ISLAND AVENUE
109B-B-30

CLIFF ISLAND

Mr Warren McDonald
Inspector of Bldgs.
Portland Me.

There is not sufficient information on your plan and your application for the building permit to cover alterations in your boat house on Cliff Island, so that I may be reasonably certain that the work will comply with Building-Code requirements:

KITCHEN OF
GLENWOOD
COTTAGE
W.A. BLACK

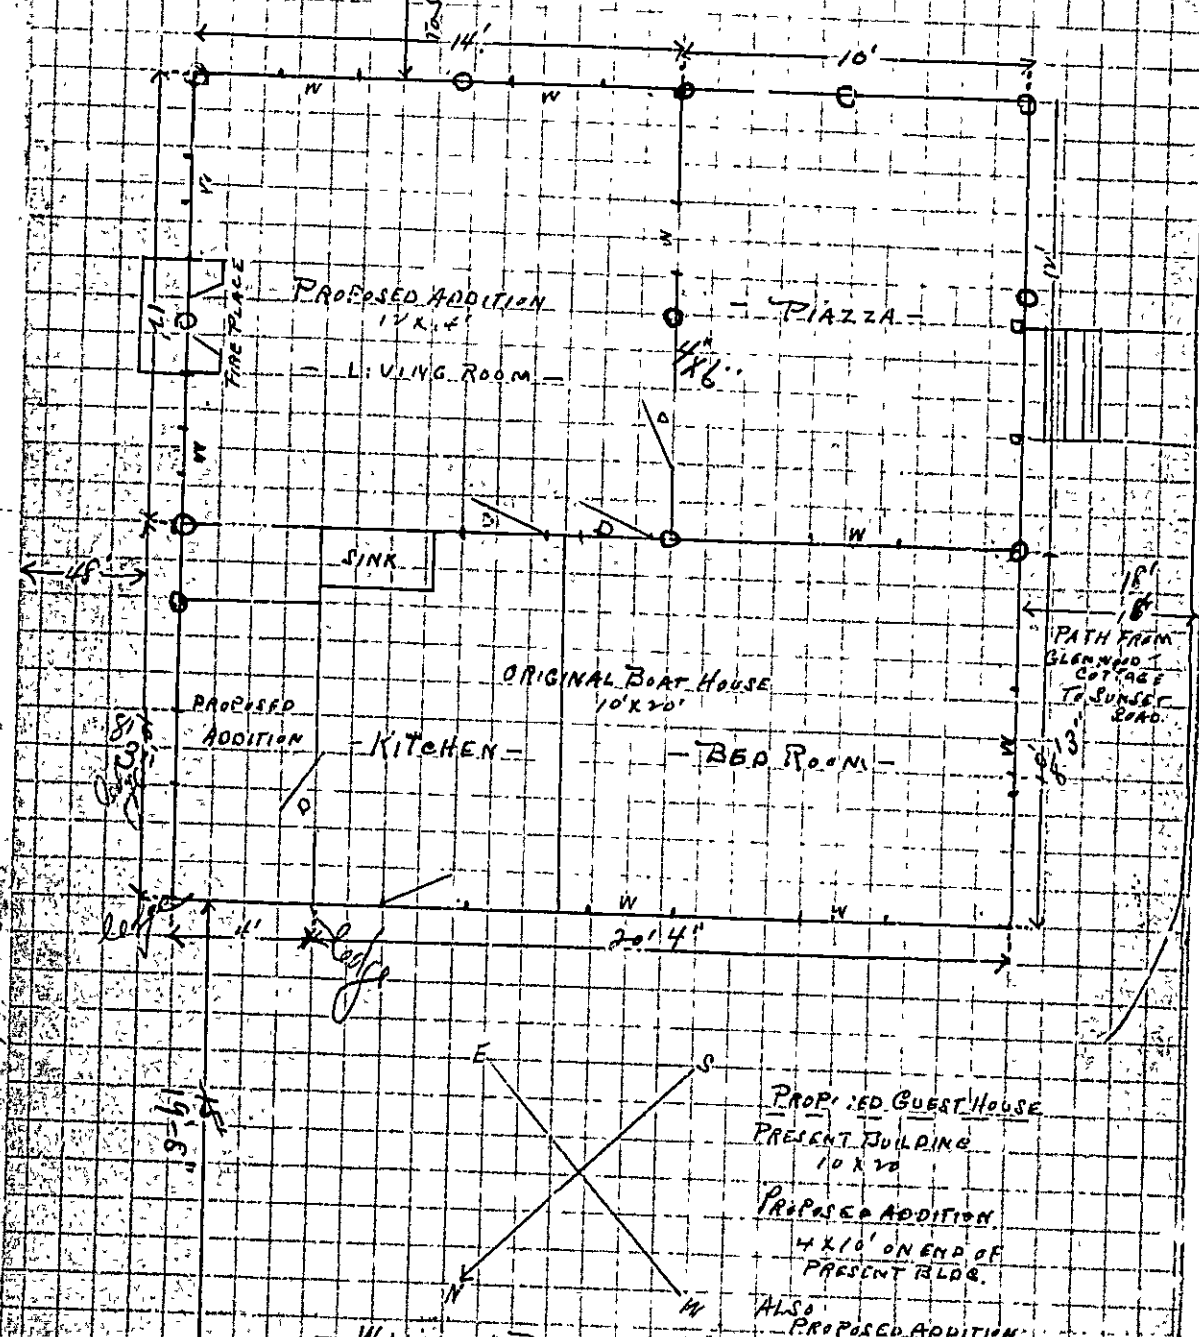
Referring to the place which you have had Mr. Yeaton build on Sunset Road, Cliff Island, Mr. Hamilton from this office reports that the roof joists, in the size, and spacing used, are not adequate to support the load.

Mr. Hamilton has talked with Mr. Yeaton in this office about the matter, suggesting a girder underneath the new roof rafters presumably in the middle of their spans.

In accordance with the instructions given in your letter of Aug 8, 1938 regarding the Plaza Roof which I recently put on my little guest house, I wish to state that I have put in a 2" x 8" timber 14 ft. long half way down the length of the 2" x 4" rafters and all rafters rest on it and nailed to it as well. Each end rests on good solid wood, one end rests on the roof of the old boat house with a plate of 2" x 6" laid on the roof first to distribute the weight on that end, and the other end rests on a block of wood setting on the ^{upper} edge of the 2" x 6" that the roof rests on. The 14' plank is wedged and the upper edge was a little crowned, so I put that edge up. I did a good job & hope it meets with your approval. Yours. William A. Black

WILLIAM A. BLACK
@ LITTLE ISLAND
PORTLAND, ME.
BLDG PERMIT APPLIED FOR

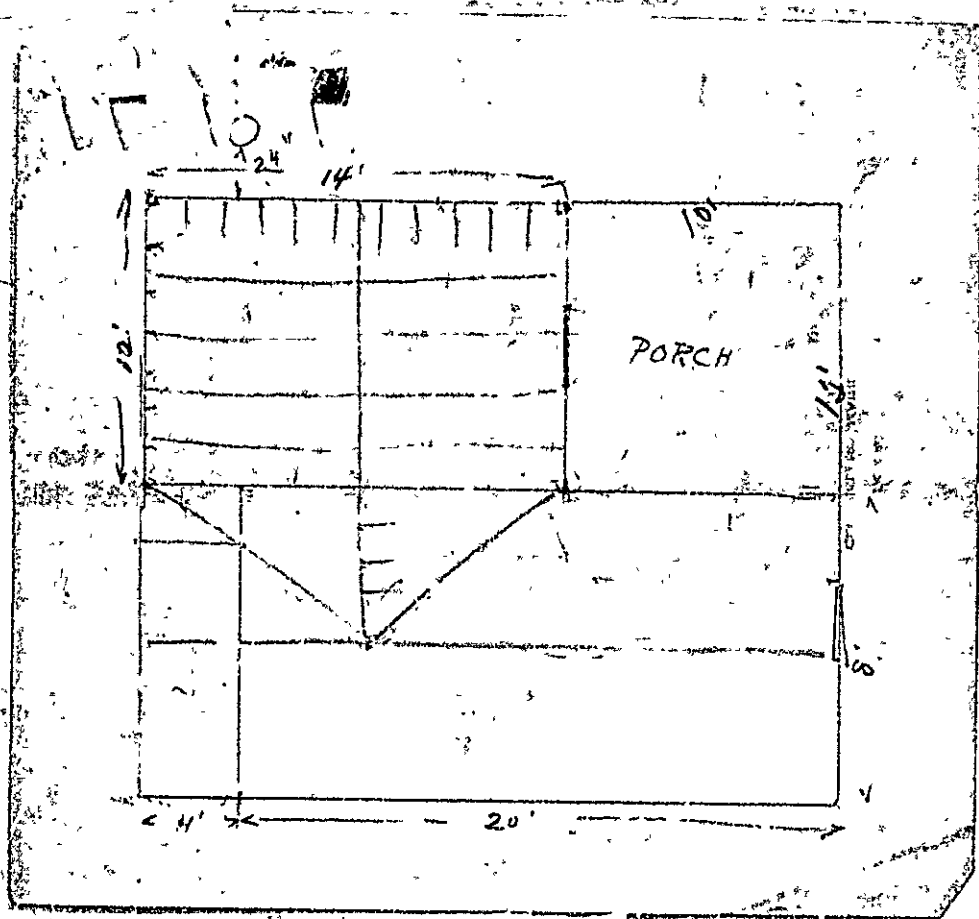
I presume that the 4 x 6 sills will be set with the 6 inches vertical, but there is nothing to show the location of the posts or piers supporting the sills. Therefore we are not aware of the spans of the sills and therefore cannot check the capacity of the sills to support the 40 lbs. per square foot live load on the living room and piazza floors plus the dead load of floors, and walls plus the live and dead load of the roof. It is evident that a girder will be needed beneath the first floor between the living room and the piazza as the wall over is to be a carrying partition in that it supports part of the roof load.

The application shows 2-2 x 4 for corner posts. The Code requires that new corner posts be at least 4 x 4 and all one piece in cross-section, that is not built up of two pieces of 2 x 4.

The application says there is to be no chimney, but the plan furnished later shows a fireplace in the new living room.

The dimensions of the open spaces about the building that are shown seem to check, but there is no dimension to the property line shown on the north-east side of the building.

I am wondering if you are aware of the special requirements as to framing such as the carrying of the studs down to the sills and girder instead of placing them on the floor; double headers over window and door openings and short studs under each end of such headers to support them; 1 x 3 cross-bridging between the floor joists; spacing all studs 16" on centers (this may be increased to 24" if the building is to be used merely as a summer cottage.
